APPLICATION NO.	FILING DATE	FIRST NAMED INVENTOR	ATTORNEY DOCKET NO.	CONFIRMATION NO.
10/699,208	10/31/2003	Leonard Stevens	64104-00002USPT	2784

<b>Office Action Summary</b>	Application No. 10/699,208	Applicant(s) STEVENS ET AL.	
	Examiner Michael G. Mendoza	Art Unit 3731

## **DETAILED ACTION**

**Fig. 12**

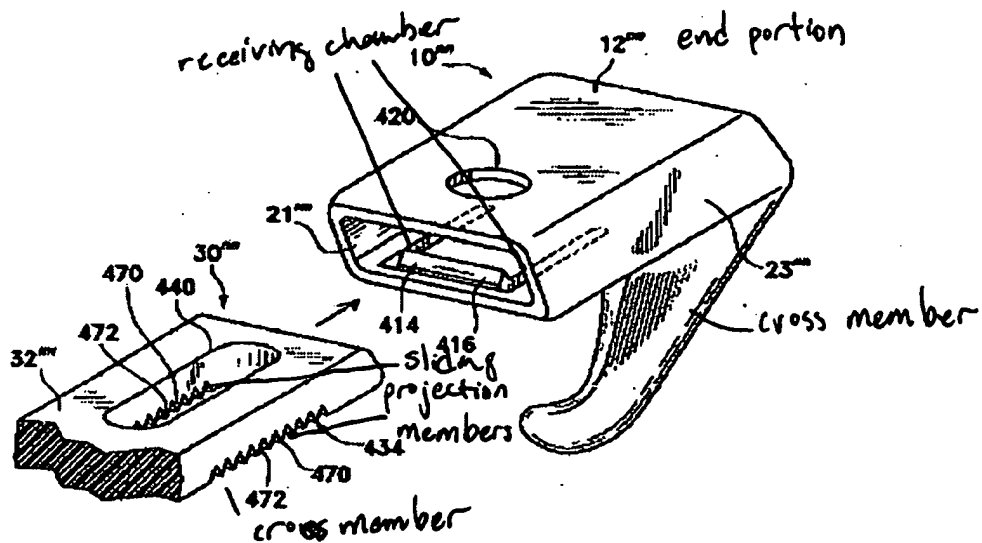
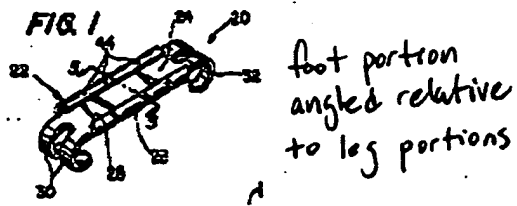
12. Regarding claims 1 and 2, Hogendijk et al. disclose in Fig. 12 the device comprising impermanently joined sliding (10''') and receiving (30''') attachment structures. Each structure has a cross member (see Fig. 12 inserted below) and an end portion (12 '''). Fig. 12 is a structurally analogous embodiment of Fig. 1 (col. 3, lines 65-67), which more clearly shows the receiving attachment structure's end portion (32) and the plurality of sternum engagement surfaces (bottom of 17 and 72, 20, 22, 40, 42). Hogendijk et al., however, disclose in Fig. 1 only one foot (20, 40) and leg (16, 36) portion on each structure and not a plurality of foot and leg portions on each structure. Crossett et al. disclose in Fig. 4 a plurality of foot (36, 38) and leg (30, 32) portions on each structure. This additional structure is simply a duplication of parts, and it is well known to add another leg or foot portion to enhance the securement of the sternum clamp to the sternum. It would have been obvious to one having ordinary skill in the art at the time of the invention to add another leg and foot portion to each structure to strengthen attachment of the device to the sternum.

13. Regarding claim 2, Hogendijk et al. disclose in Fig. 12 the receiving structure (30''') comprising a resiliently tensioned locking member with angularly disposed teeth

like structures (47) outwardly positioned at first (bottom 470) and second (top 470) ends of the locking member. Hogendijk et al. further disclose a securing aperture (440) substantially centered there between.

**Fig. 9**

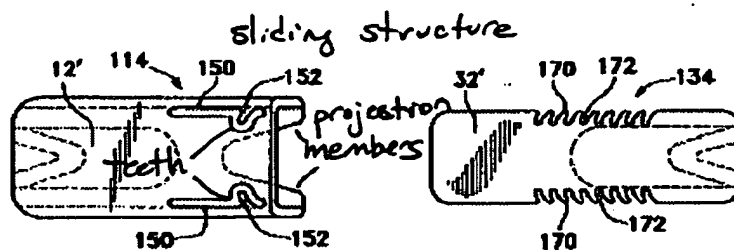
14. Regarding claims 1, 3-10, 12, and 15, Hogendijk et al. disclose in Fig. 9 the device comprising impermanently joined sliding (114) and receiving (134) attachment structures. Each structure has a cross member (12', 32') and an end portion (the left and right ends of 12', 32'). Fig. 1 of which Fig. 9 is a structurally analogous embodiment (col. 3, lines 54-56), shows the plurality of sternum engagement surfaces (bottom of 17 and 72, 20, 22, 40, 42). Hogendijk et al., however, disclose in Fig. 1 only one angled foot (20, 40, the foot is angle with respect to the leg) and leg (16, 36) portion on each structure and not a plurality of foot and leg portions on each structure. Crossett et al. disclose in Fig. 4 a plurality of foot (36, 38) and leg (30, 32) portions on each structure. This additional structure is simply a duplication of parts, and it is well known to add another leg or foot portion to enhance the securement of the sternum clamp to the sternum. It would have been obvious to one having ordinary skill in the art at the time of the invention to add another leg and foot portion to each structure to strengthen attachment of the device to the sternum.

15. Regarding claim 3, Hogendijk et al. disclose in Fig. 9 the sliding structure (114) comprising a plurality of projection members (see Fig. 9 below) with angularly disposed teeth like structures (152) inwardly positioned on each innermost surface of each projection member.

17. Regarding claim 7, Hogendijk et al. disclose in Fig. 9 the receiving attachment structure (134) comprising a securing means (170) to facilitate the operative securing of the structures to one another. The teeth (170) of one structure engage the teeth (152) of the other structure to secure the structures to one another.
